DRAINAGE DESIGNER'S RESPONSE

FORMER POST OFFICE,
EASTLEIGH

Project No. PMC285

Figure 1. EA's Flood Map for Planning – site outlined in red

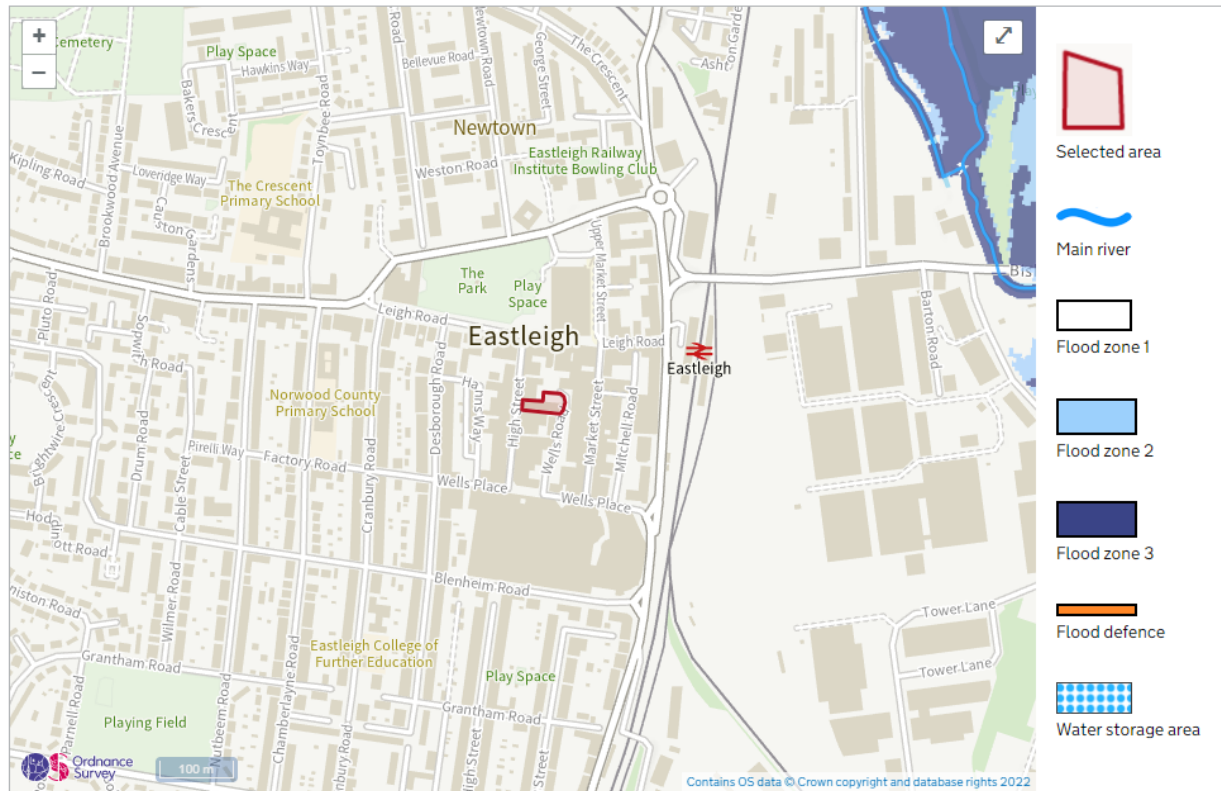
The revised drainage strategy has not considered flood risk at this site any further than the original strategy.

The site is less than 1 ha and lies within Flood Zone 1. Refer to image below from the EA's Flood Map for Planning. No further assessment of flood risk other than surface water drainage exceedance events has therefore been considered necessary.

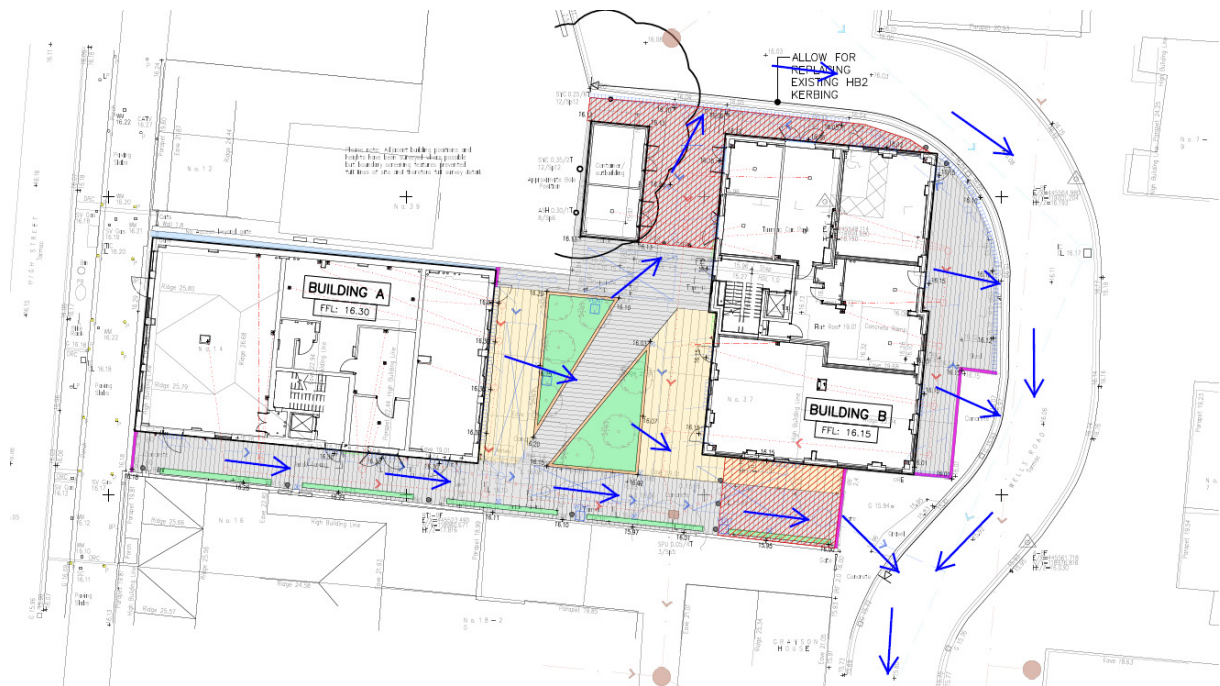
Exceedance flood flow routes have been described but have not been shown on a plan

Refer to diagram below for exceedance flow routes
